PRELIMINARY/FINAL DRAINAGE REPORT FOR HIGH PLAINS FILING NO. 1

PCD FILE NO's: SP-18-003
SF-18-024

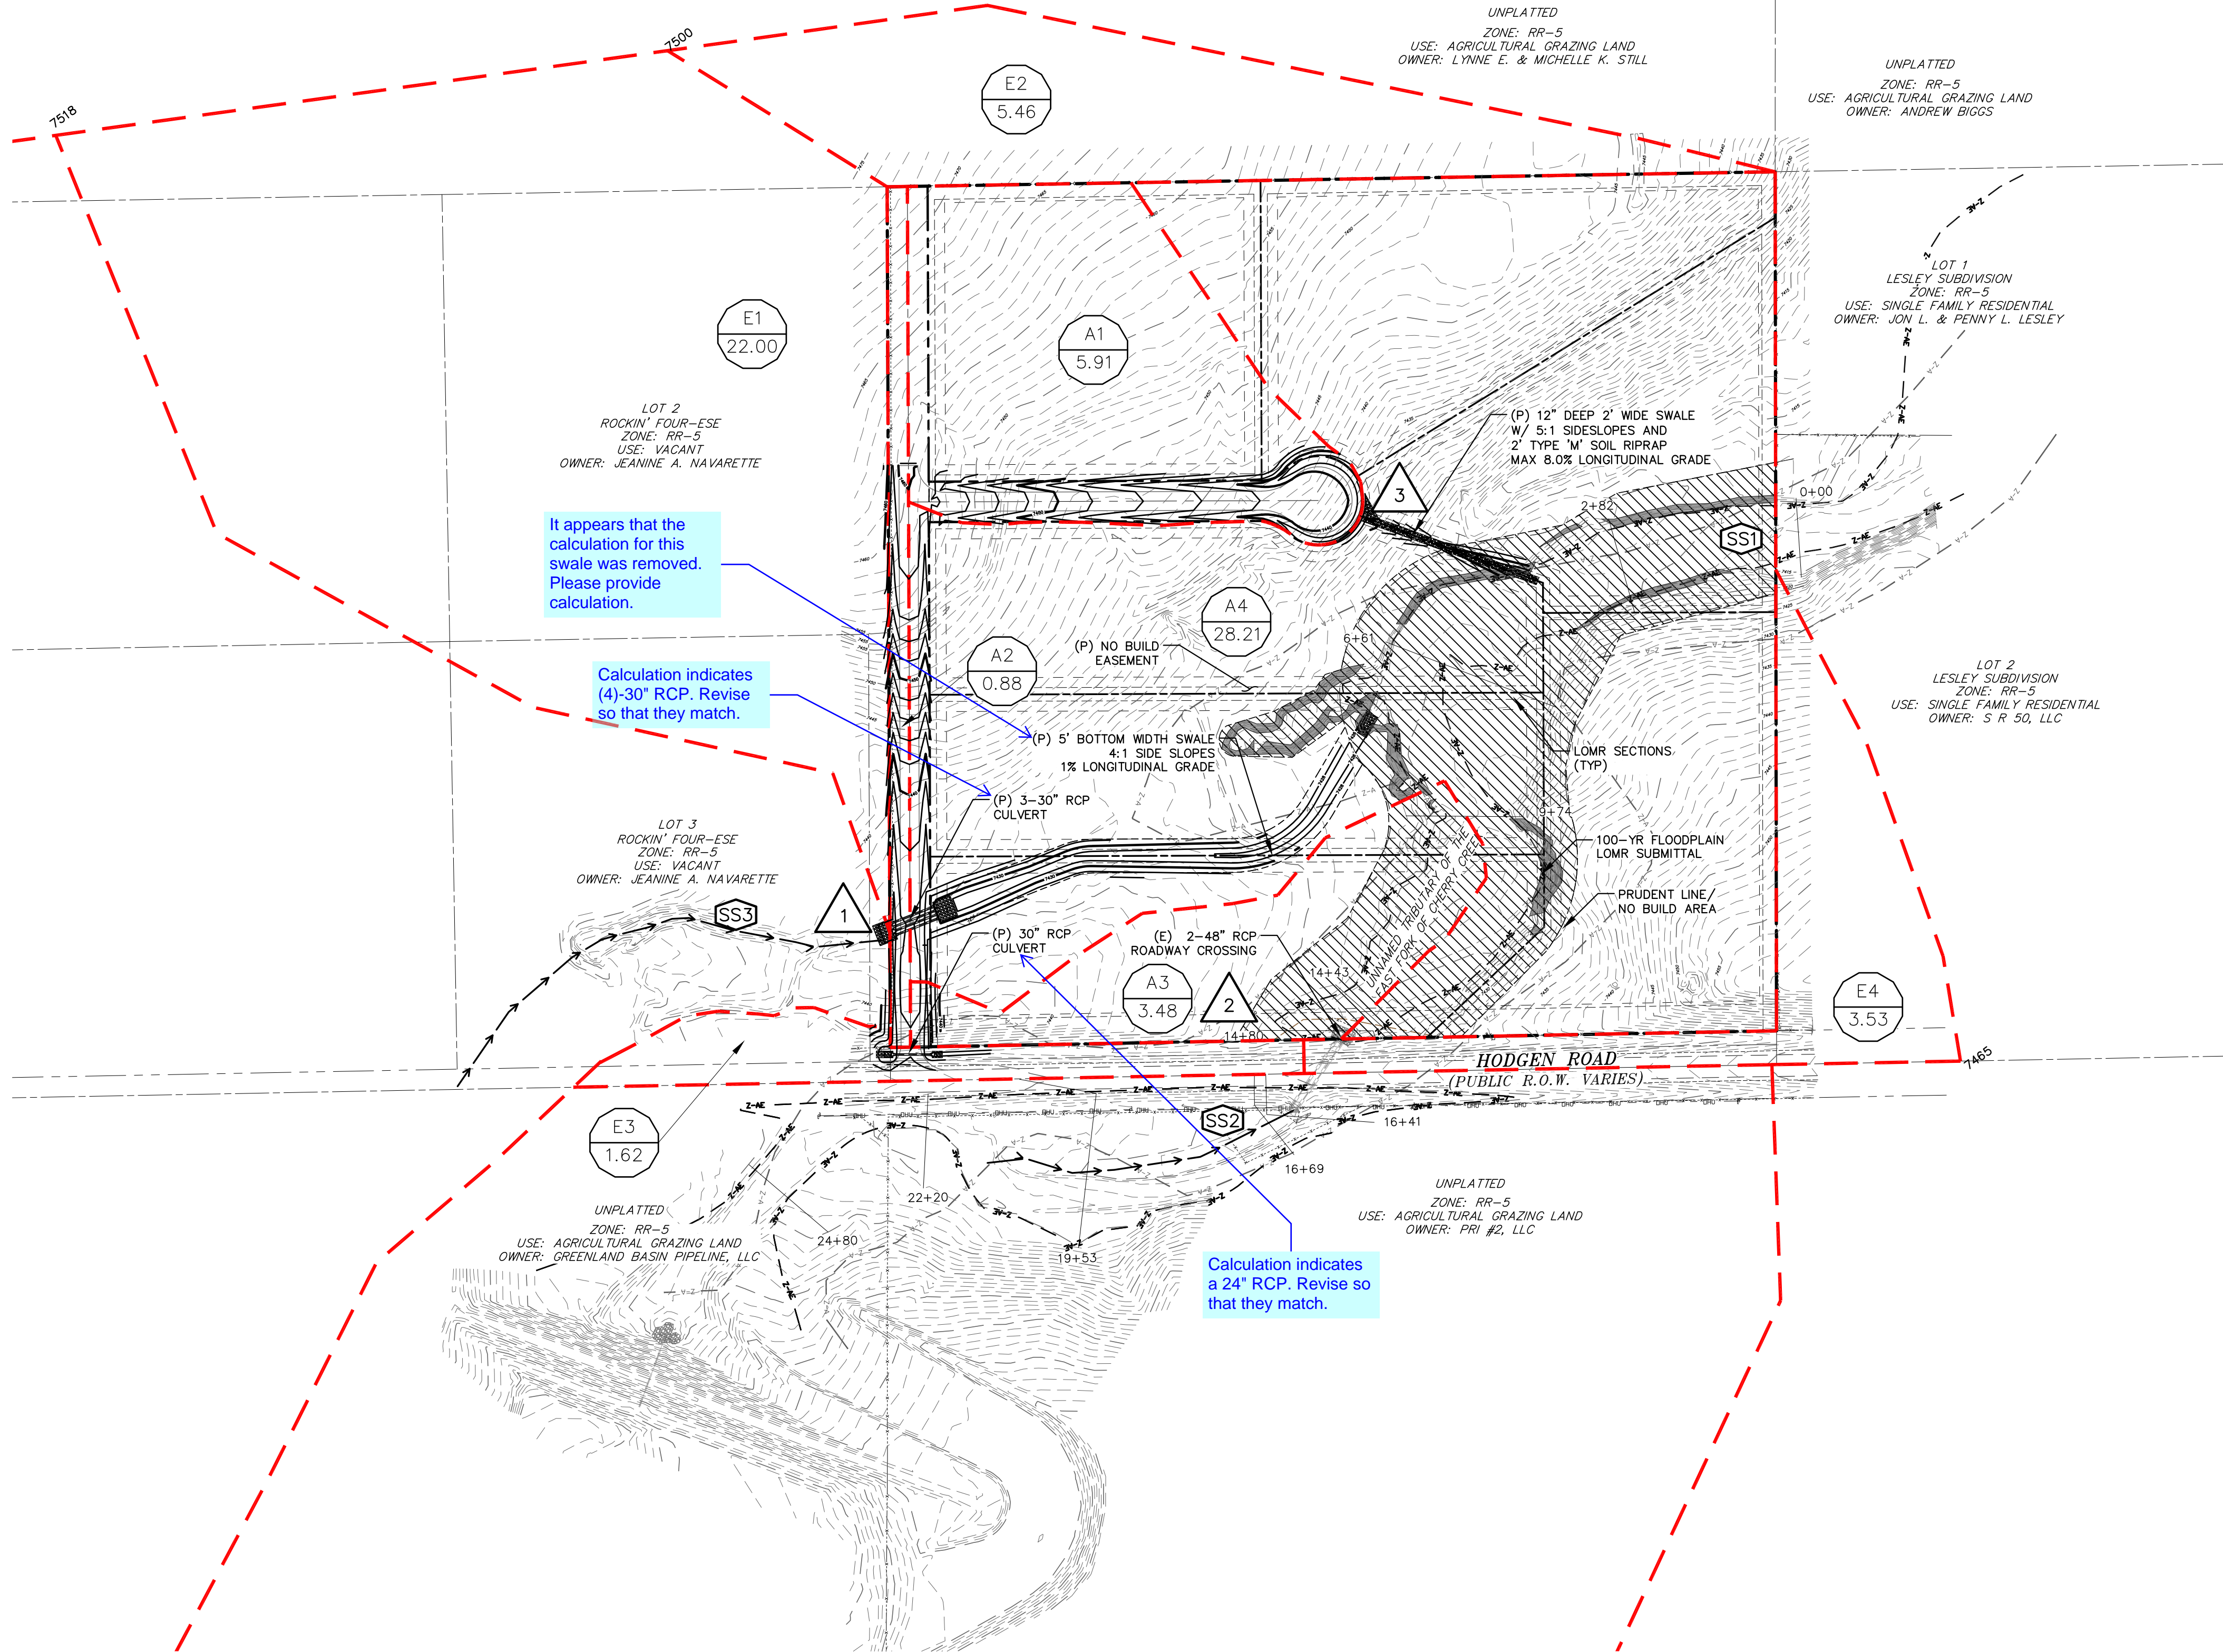
It appears that the calculation for this swale was removed. Please provide calculation.

Calculation indicates (4)-30" RCP. Revise so that they match.

Calculation indicates a 24" RCP. Revise so that they match.
